Manchester Oxford Road

This document has been created to summarise the lighting and CCTV proposals on the exterior of Manchester Oxford Road station to address Manchester City Council comments and provide justification for decisions made. This is not a design document and should be read alongside the approved design deliverables produced by others for the project.

Further to the meeting between Network Rail and Manchester City Council (MCC) on Monday 18/12/2023 to review proposals for Manchester Oxford Road Station and specifically the impact on the grade 2 listed structure this document has been compiled in relation to the proposed exterior CCTV and lighting works only.

Figure 1 - Extract of 175726-STR-XX-XXXX-DRG-EAR-000904 - 3D View - Lighting & CCTV & M&E revision C02 dated 19/01/2024)

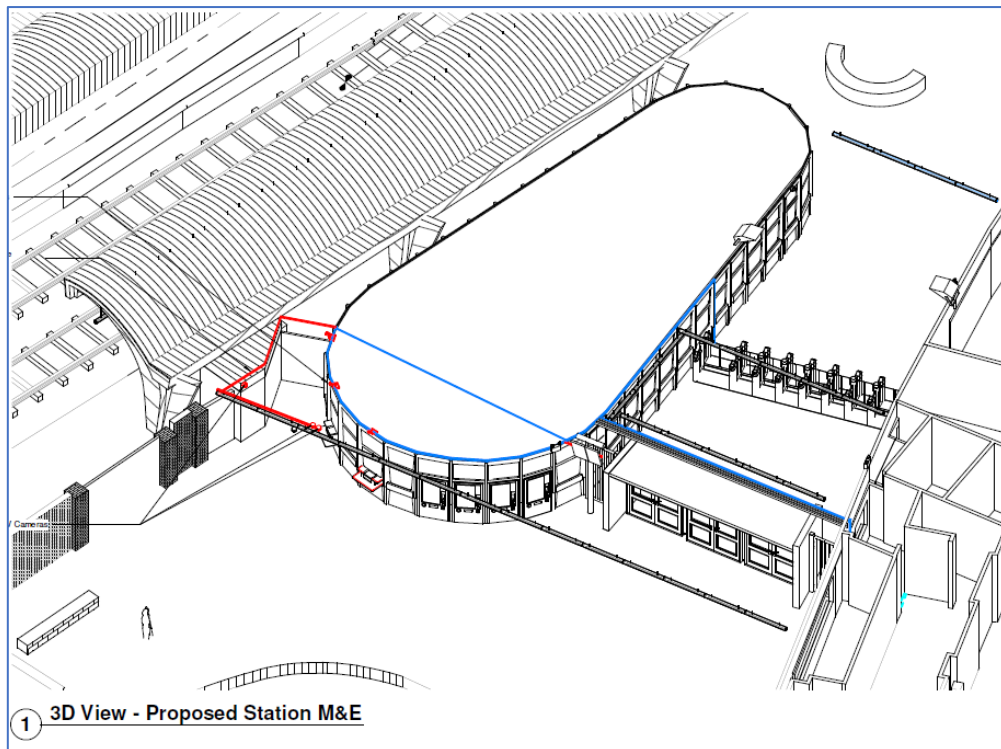
Following feedback from the council on 18/12/2023 and in January 2024 a review of these proposals has been undertaken and the following changes are proposed:

1. Number of lights proposed at the front of the station reduced from 5 to 3 – This will ensure that new ticket desks are appropriately lit to meet current designs standards and allow the ticket office to safely open. The works will not however fix existing deficiencies regarding lighting levels adjacent to the ticket vending machines and in the station concourse which will require a review in the future and will be explored separately as per point 3.
2. The lighting proposed is that agreed with MCC – Philips LED floodlights Gen 3, see Figure 3
3. A further detailed design will be undertaken to look holistically at the lighting at the station front and concourse which will consider the lighting unit type, colour, location, number and interaction with other lighting. This review will be undertaken with MCC input.

Figure 4 - Extract of 175726-STR-XX-XXXX-DRG-EAR-000904 - 3D View - Lighting & CCTV & M&E revision C02 dated 19/01/2024

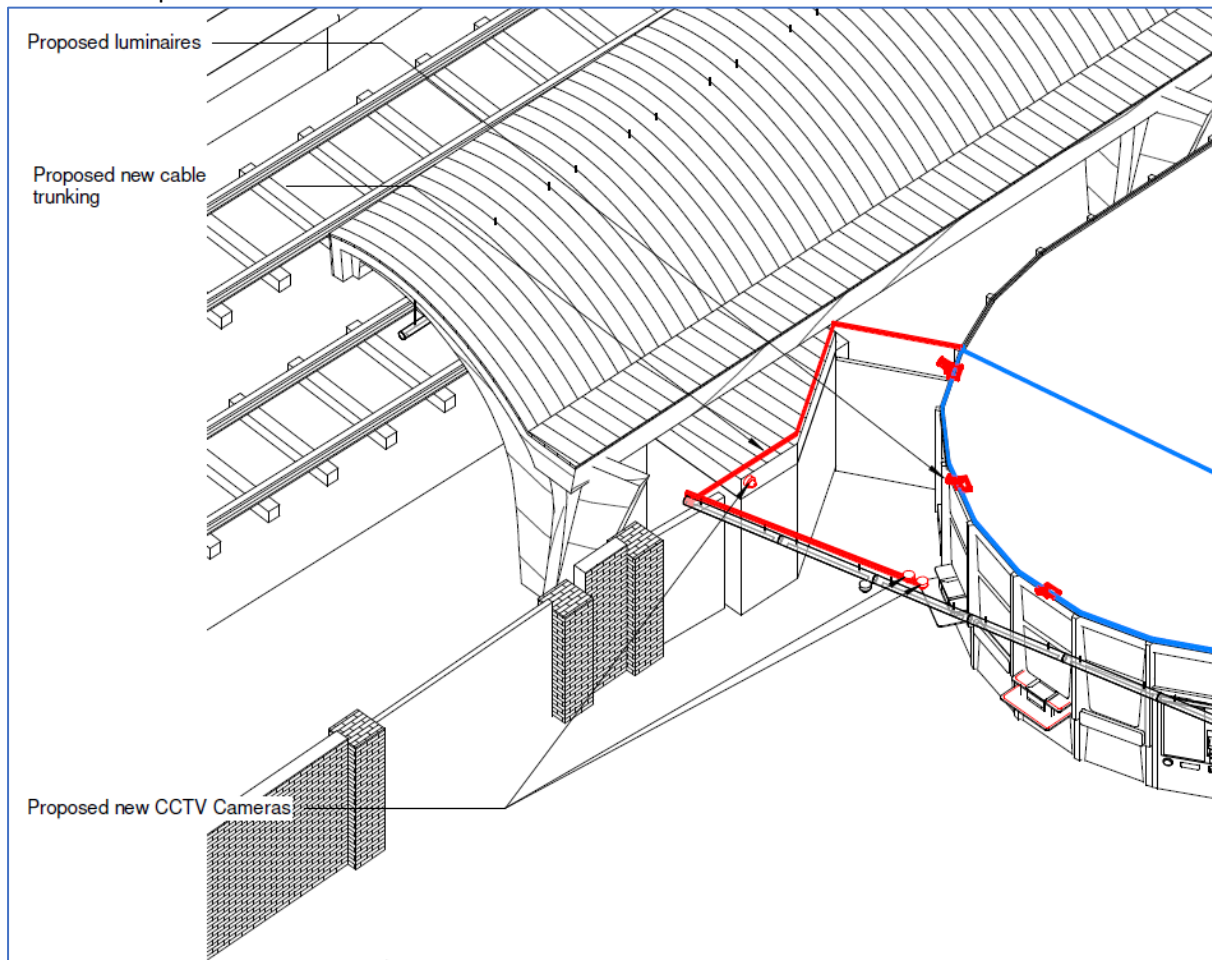
This project was originally proposing to install 5No. new CCTV cameras at the front of the station, 4No. on the underside of the station canopy and 1No. on the existing brick wall separating the station exterior and platform 4 to the south.

1. Number of CCTV cameras proposed reduced from 5No. to 3No. – This will ensure that new ticket desks are appropriately covered to meet current designs standards and allow the ticket office to safely open. The works will not however fix existing deficiencies regarding the CCTV system as a whole which will require a review in the future and will be explored separately as part of a Northern CCTV scheme. This reduces the proposed number of cameras fixed to the canopy from 4No. to 2No. and these 2No. cameras will also be adjacent to each other but pointed in different directions. This reduces the visual impact and number of fixings into the canopy by 50% from original proposal presented on 18/12/2023. The vision plot for these cameras is shown in Figure 7.

2. The 2No. remaining CCTV cameras on the station canopy will be relocated as close to the existing strip lighting as possible and be located on the station building side to reduce visibility of the cameras on approach to the station whilst not impacting clarity of images.

3. Route of cabling to these two cameras has been reviewed and at this time an extension of the existing canopy mounted galvanized steel conduit is proposed that will sit on the building side of the strip lighting as close as possible to limit visual impact. A 25/32mm diameter circular conduit is currently proposed.

Figure 5 - Indicative proposal for a CCTV gantry at station exterior to avoid fixing to canopy.

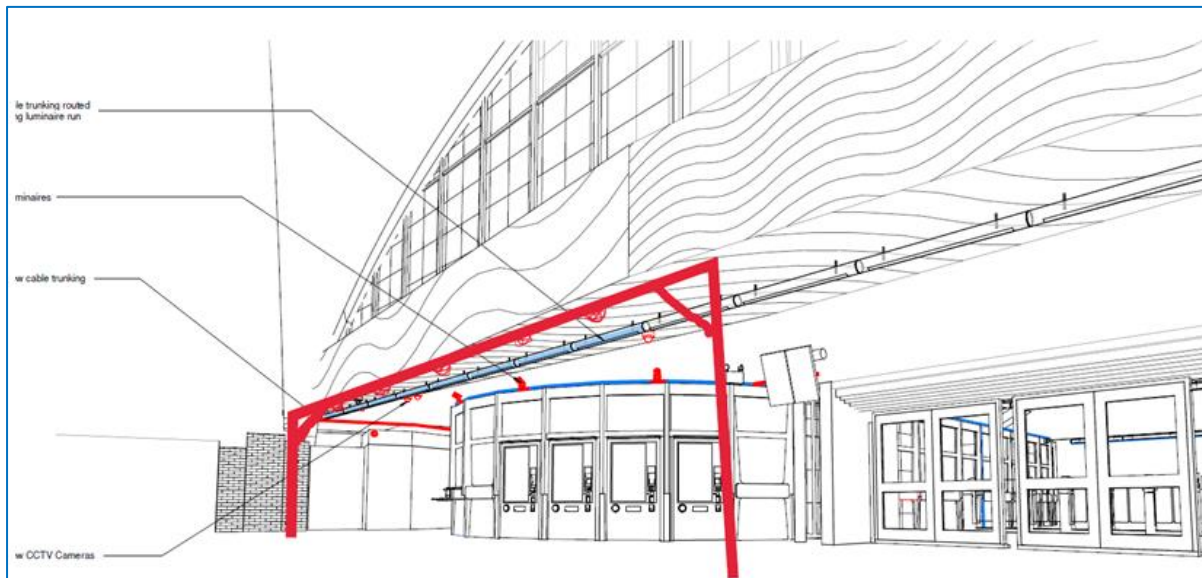
- The ticket office cannot open without the required CCTV coverage being achieved.
- Gantry brackets or CCTV columns were considered but the opinion around designing and installing a gantry(s) or goal post(s) arrangement in which to rig up or locate the CCTV cameras was thought to be too oppressive an installation and would further ruin and obstruct the view of the station exterior when approaching the station. Any new columns would also be detrimental to passenger flow.

Figure 7 - Extract of CCTV vision plot from Telecoms Detailed design (2No. cameras removed from scope following MCC feedback denoted with pink X and pink vision plot outlines)

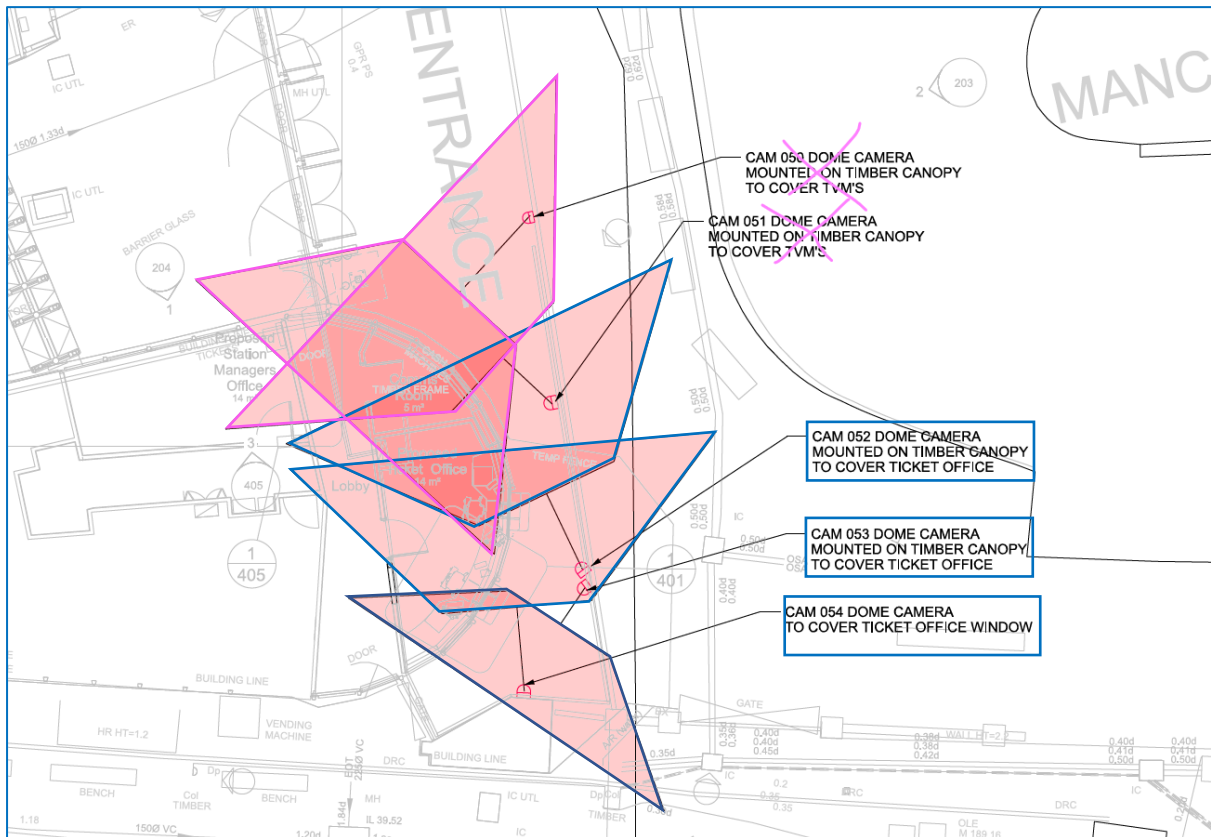
Following feedback from the council on 18/12/2023 a review of these proposals has been undertaken and the following changes are proposed:
